ECE/TRANS/WP.29/GRSP/2009/22
23 September 2009

REGULATION No. 11
(Door latches and hinges)

Proposal for the 04 series of amendments to Regulation No. 11

Submitted by the expert from the European Commission */

Model A

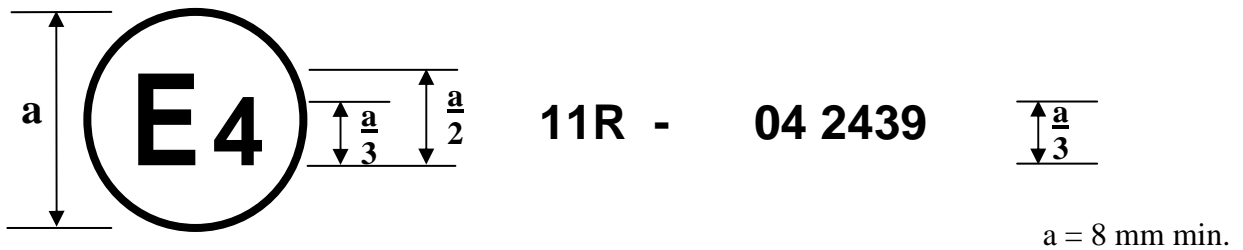
The above approval mark affixed to a vehicle shows that the vehicle type concerned has, with regard to door latches and door retention components, been approved in the Netherlands (E 4) pursuant to Regulation No. 11, under approval number 042439. The first two digits of the approval number indicate that the approval was granted in accordance with the requirements of Regulation No. 11 as amended by the 04 series of amendments.

Model B

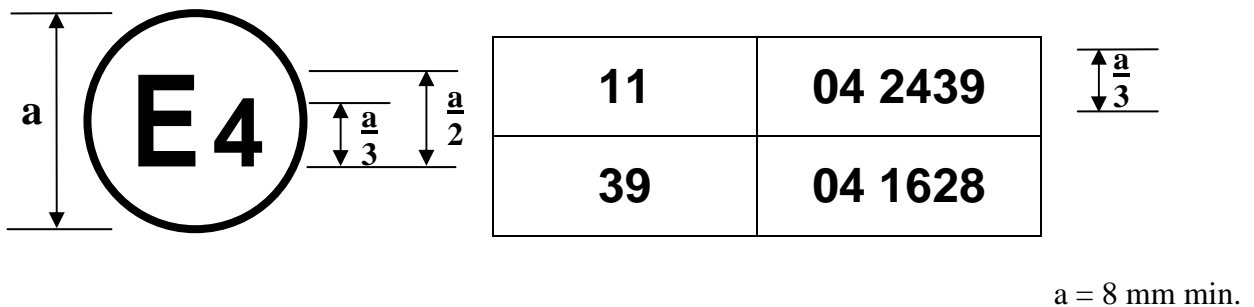
The above approval mark affixed to a vehicle shows that the vehicle type concerned has been approved in the Netherlands (E 4) pursuant to Regulation No. 11 as amended by the 04 series of amendments and Regulation No. 39, as amended by the 04 series of amendments 1/."

Figure 7-1

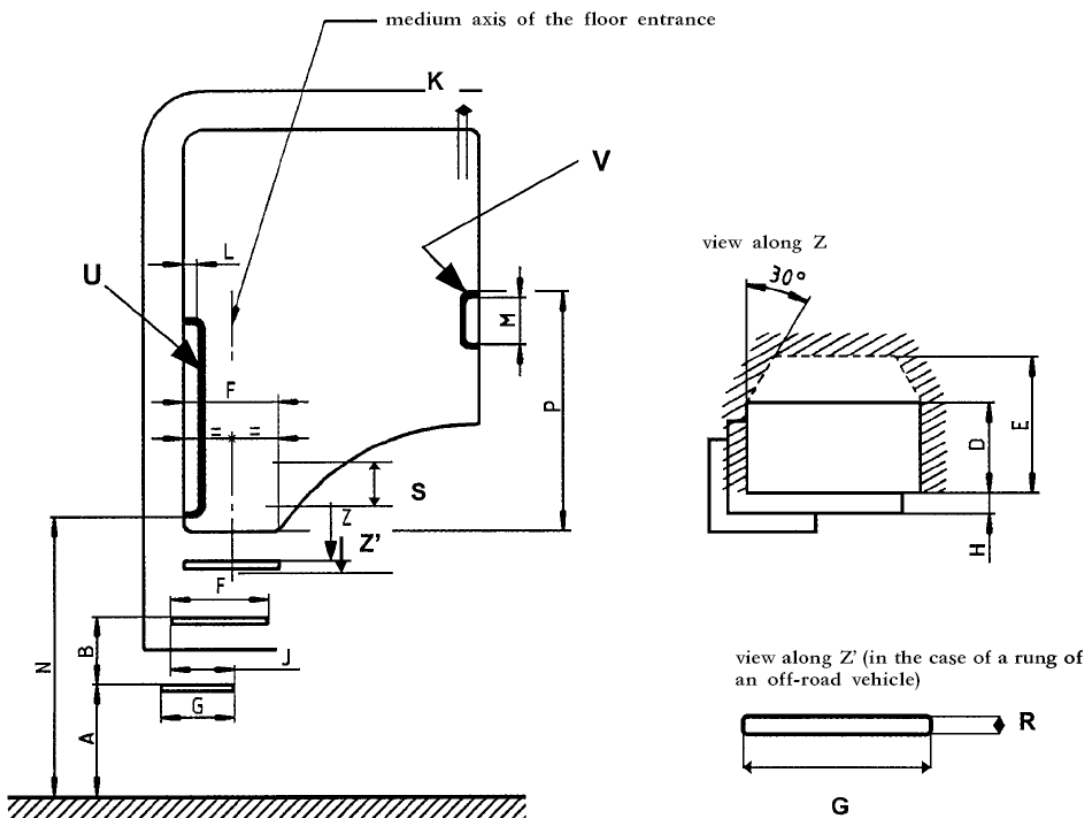
- 1. Access steps to the driver's compartment (see figure 7-1)**
 - 1.1. The distance (A) from the ground to the upper surface of the lowest step, measured with the vehicle in running order on a horizontal and flat surface, shall not be more than 600 mm [400 mm].**

- 1.2. The distance (B) between the upper surfaces of the steps shall be not more than 400 mm [350 mm]. The vertical distance between two subsequent steps shall not vary by more than 50 mm. The last requirement shall not apply to the distance between the uppermost step and the cab floor.**

- 1.3. In addition, the following minimum geometrical specifications shall be fulfilled:**
 - (a) step depth (D): 80 mm**
 - (b) step clearance (E) (include step depth): 150 mm**

- (c) step width (F): 300 mm [230 mm]**
 - (d) width of the lowest step (G): 200 mm [230 mm]**
 - (e) step height (S): 120 mm**
 - (f) transversal offset between steps (H): 0 mm**

- (g) longitudinal overlap (J) between two subsequent steps in the same flight, or between the uppermost step and the cab floor: 200 mm.**
 - 1.3.1. However, for off-road vehicles (see paragraph 1.1.1.) the value (F) may be reduced to 200 mm.**

2. Access to handholds to the driver's compartment (see figure 7-1)
 - 2.1. One or more suitable handrails and handholds or other equivalent holding devices shall be provided for the access to the driver's compartment.

- 2.1.5. The steering wheel may be considered as a handhold.
 - 2.2. The height (N) of the lower edge of at least one handrail or handhold or equivalent holding device, measured from the ground with the vehicle in running order on a horizontal and flat surface, shall not be more than 1 850 mm [1 600 mm].

- 2.2.1. However, for off-road vehicles (see 1.1.1), such distance (N) may be increased up to 1 950 mm [1 700 mm].

- 2.2.2. If the floor of the driver's compartment has a height from the ground greater than "N", this height shall be assumed as "N".
- 2.2.3. In addition, the minimum distance (P) of the upper edge of the handrail(s) or handholds or equivalent holding devices from the floor of the driver's compartment shall be:
- (a) handrail(s) or handholds or equivalent holding devices (U) 650 mm,
 - (b) handrail(s) or handholds or equivalent holding devices (V) 550 mm.
- 2.3. The following geometrical specifications shall be fulfilled:
- (a) gripping dimension (K): 16 mm minimum 38 mm maximum [25 mm minimum 30 mm maximum],
 - (b) length (M): 150 mm minimum,
 - (c) clearance to vehicle components (L): 40 mm [70 mm] minimum with open door.
